**HIGHLANDS COUNTY
BOARD OF COUNTY COMMISSIONERS
(HCBCC)
PURCHASING DIVISION**

BID NO. ITB 18-024 ADDENDUM No. 3

Project: GOVERNMENT CENTER HVAC UPGRADE

This addendum is being issued to revise the plans and specifications and address questions received.

SHEET No.:
M2.4

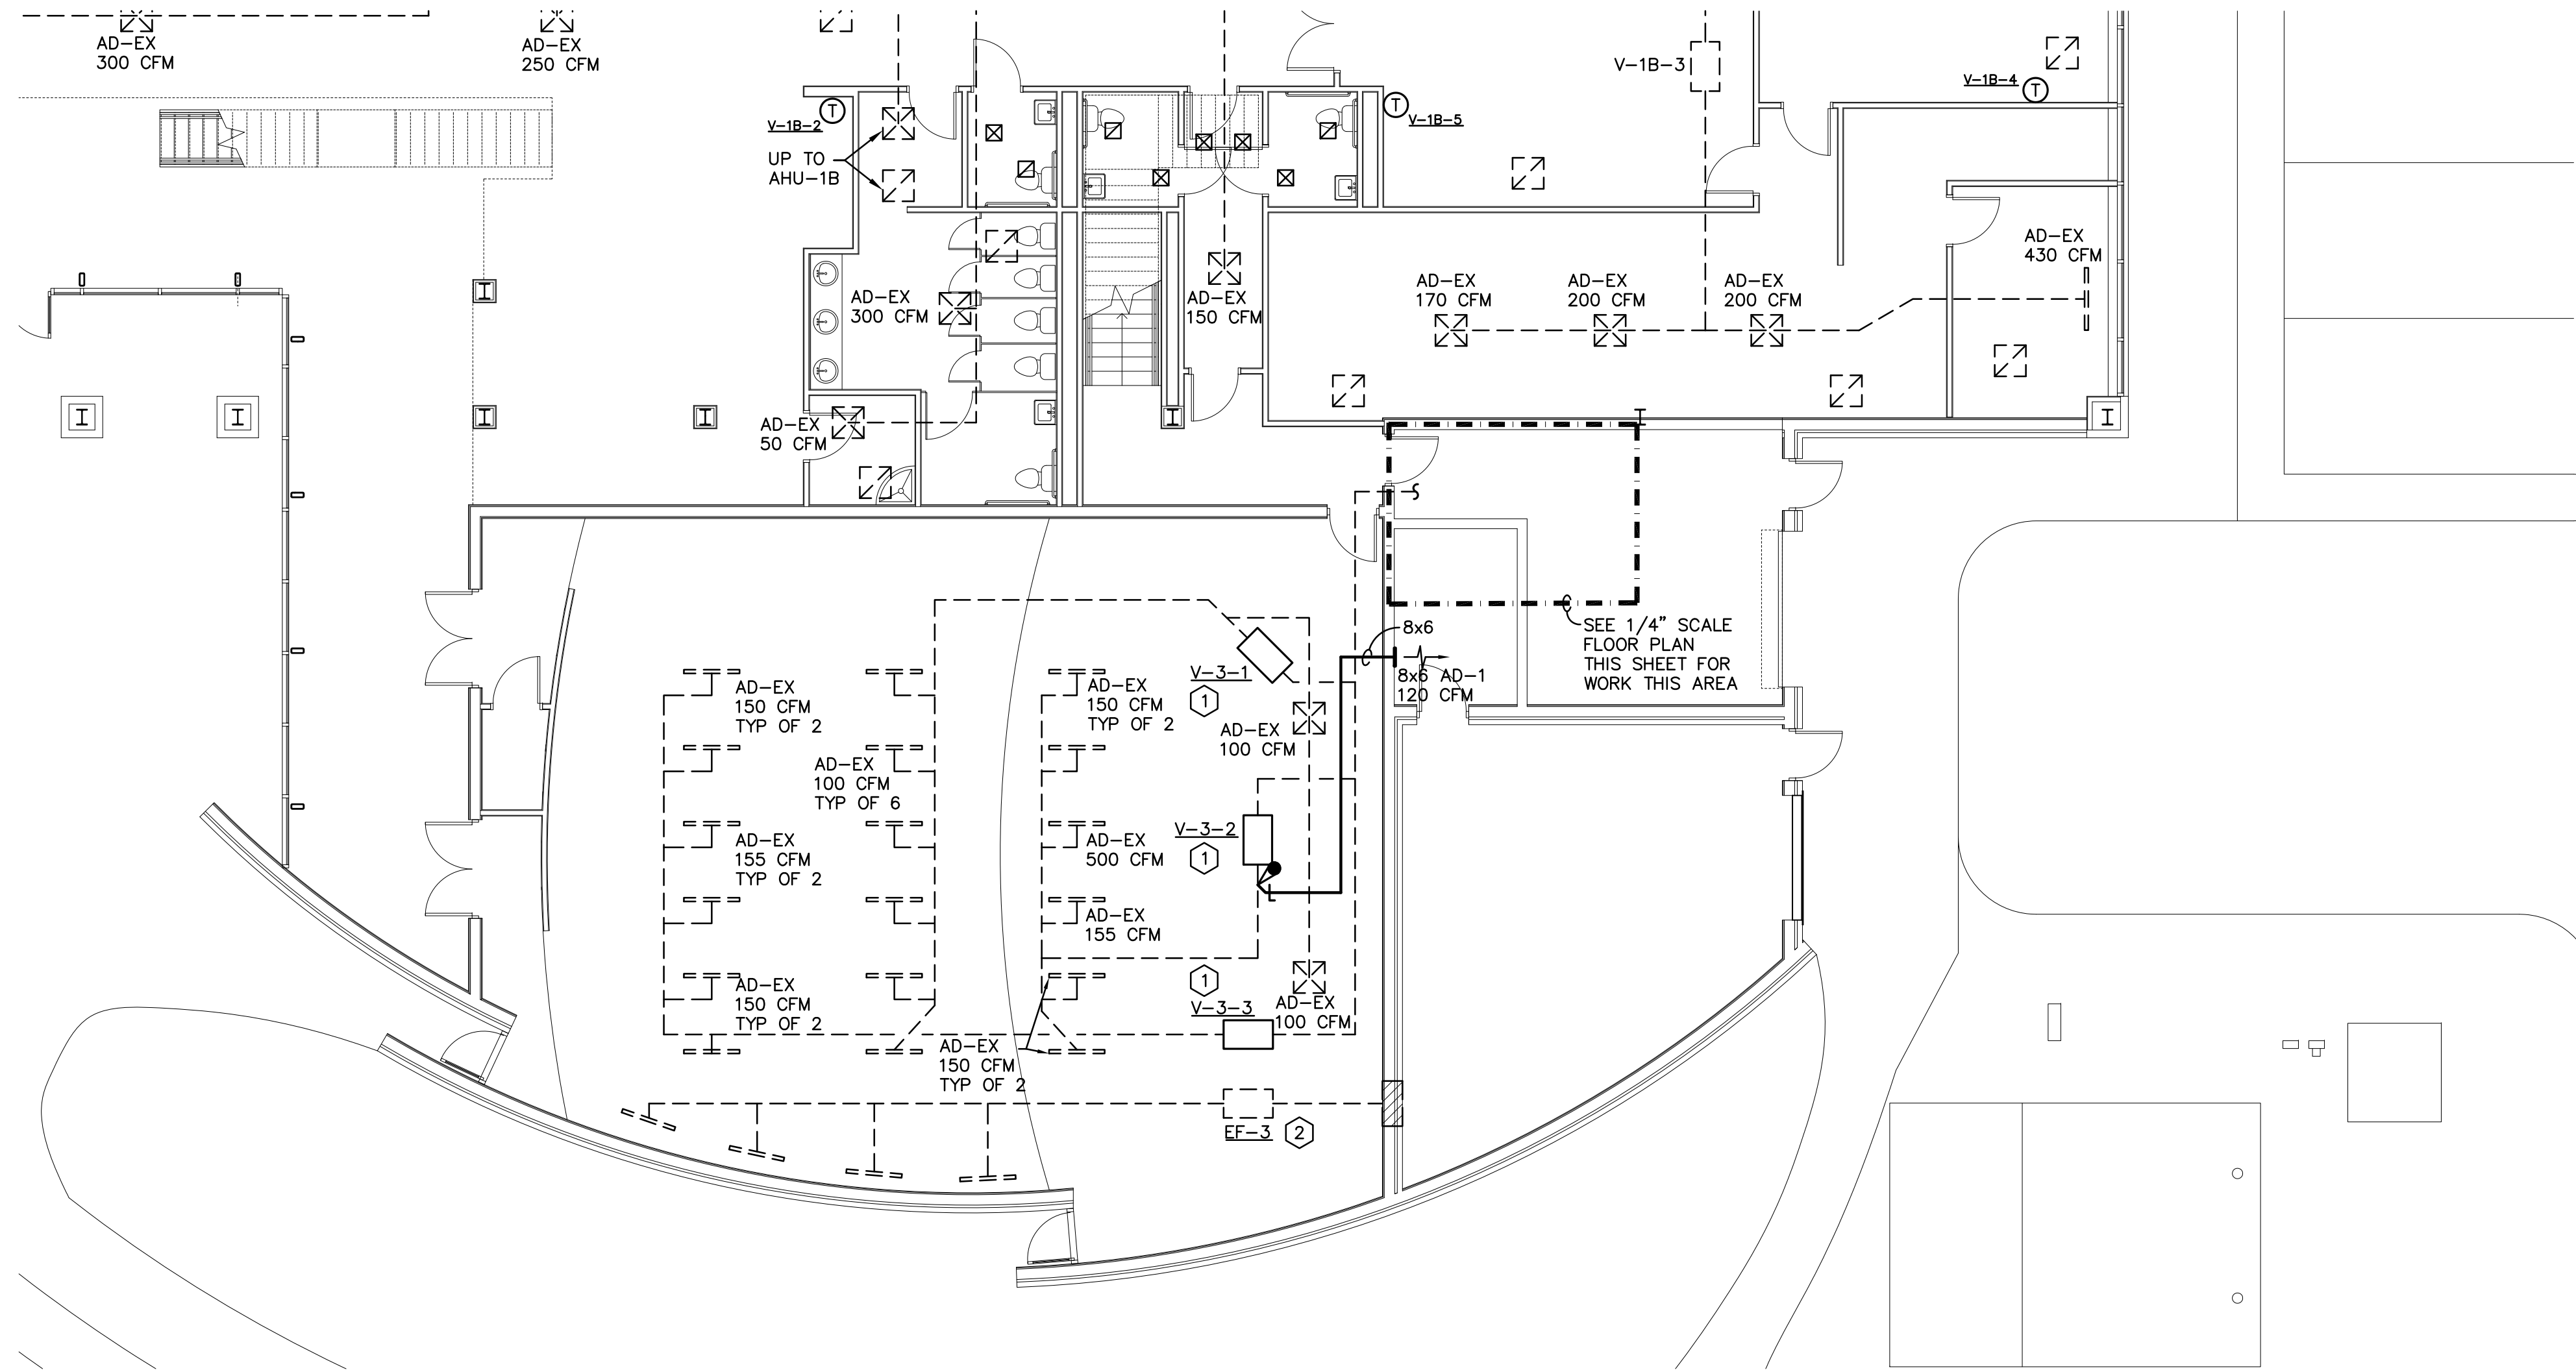
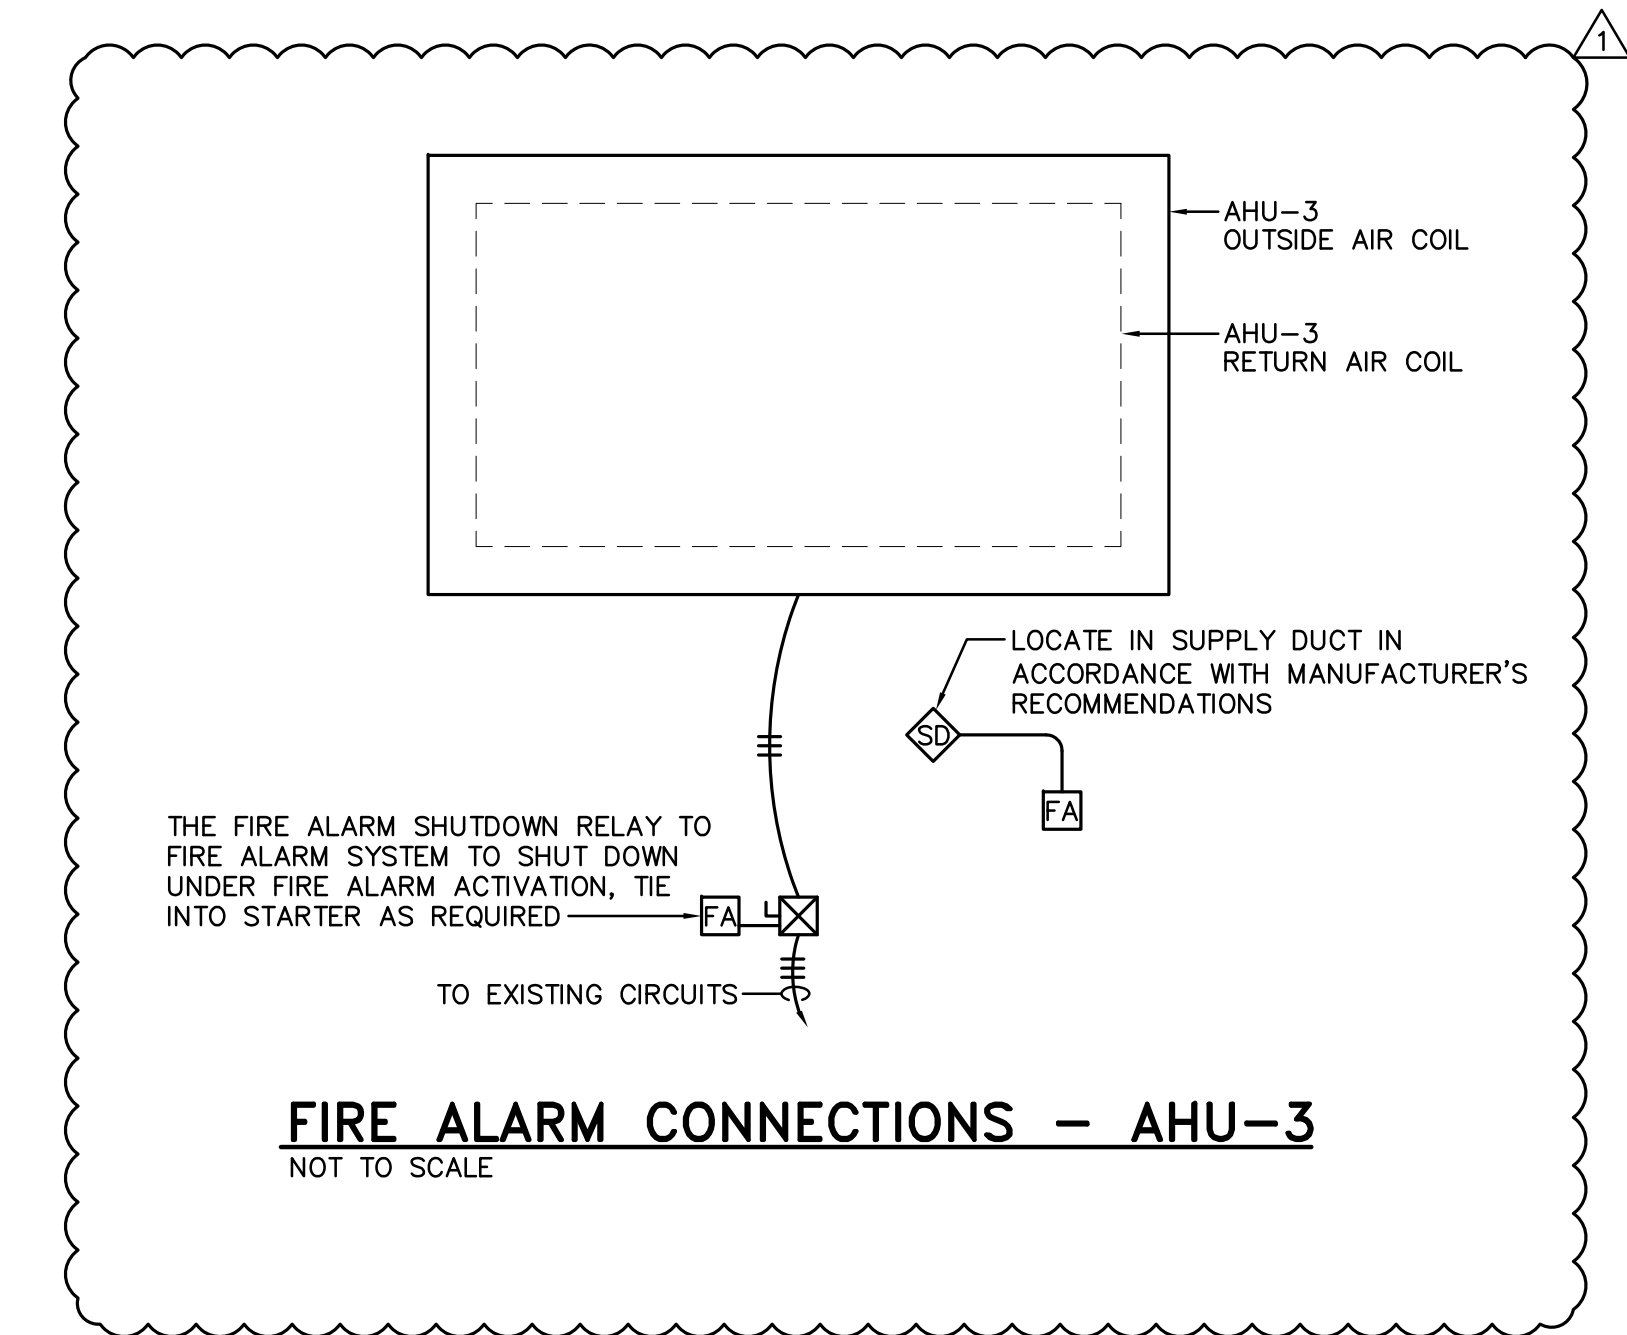
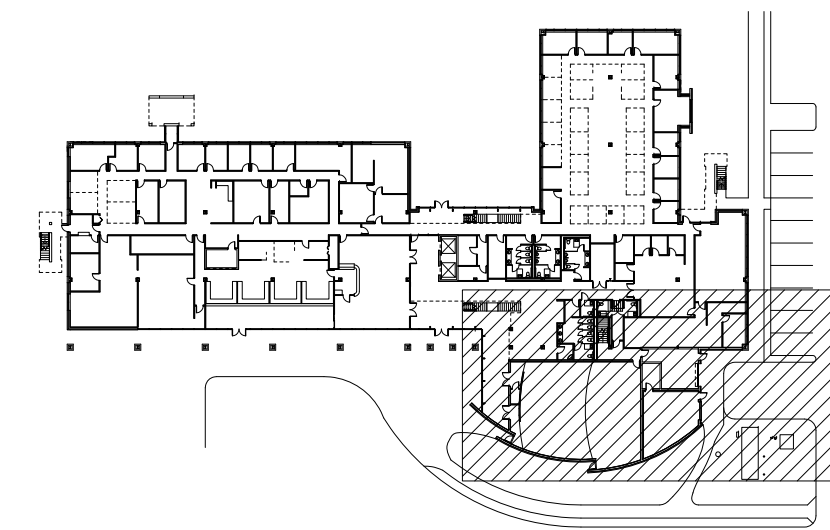
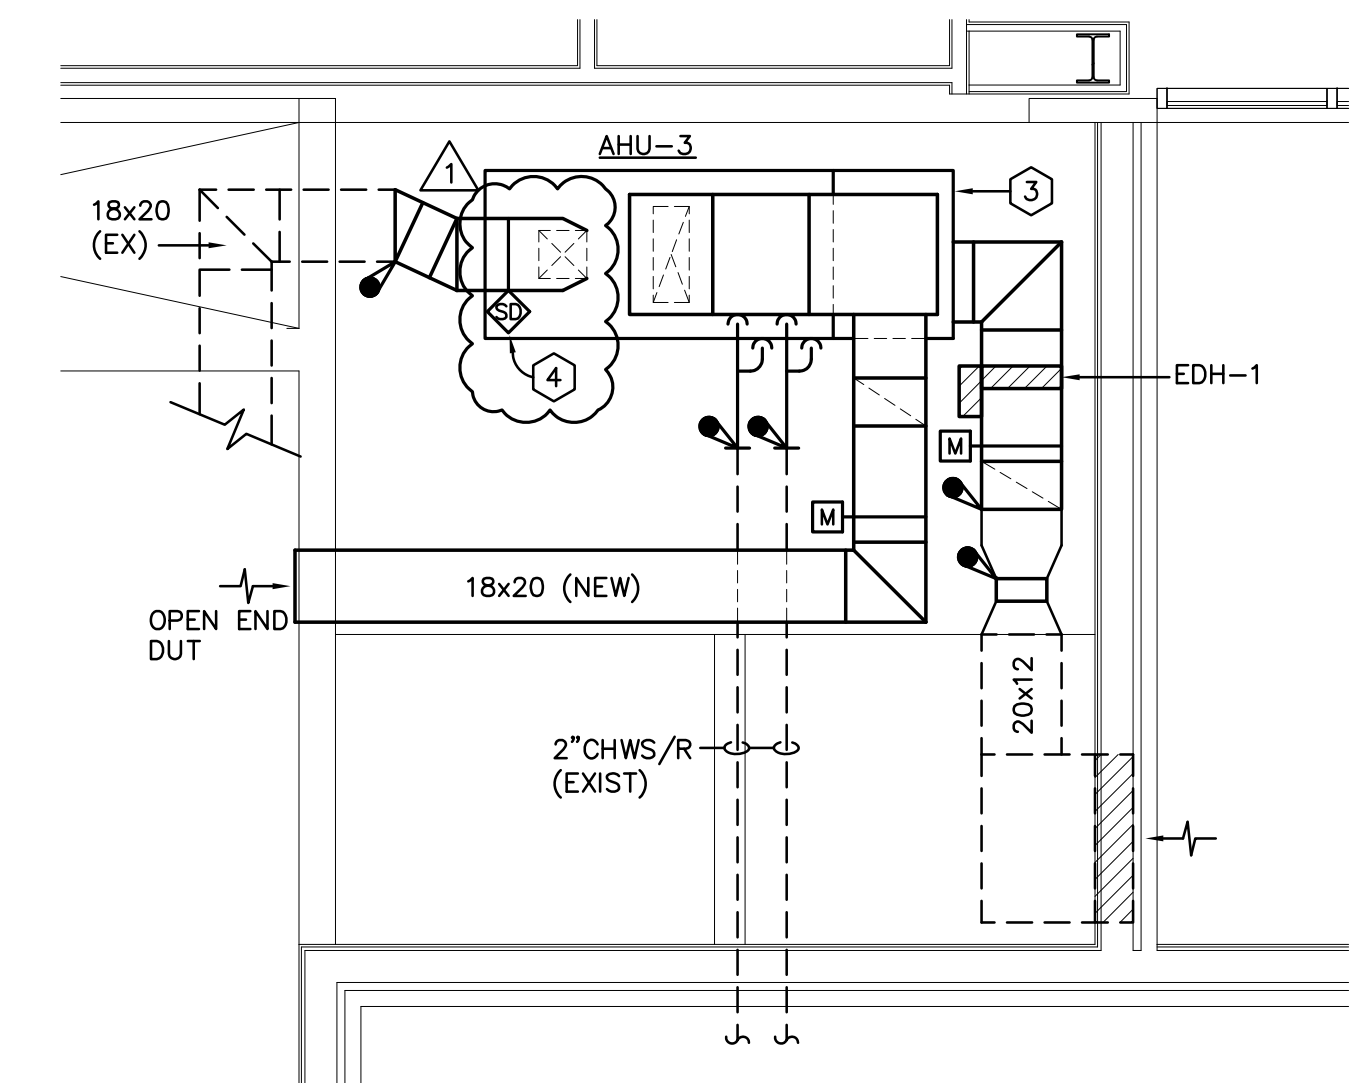
13. Does the fire or smoke alarm tie into system?

Answer: See revised sheet M2.4 included in item 2 (Revised Plans) as indicated on this plan sheet.
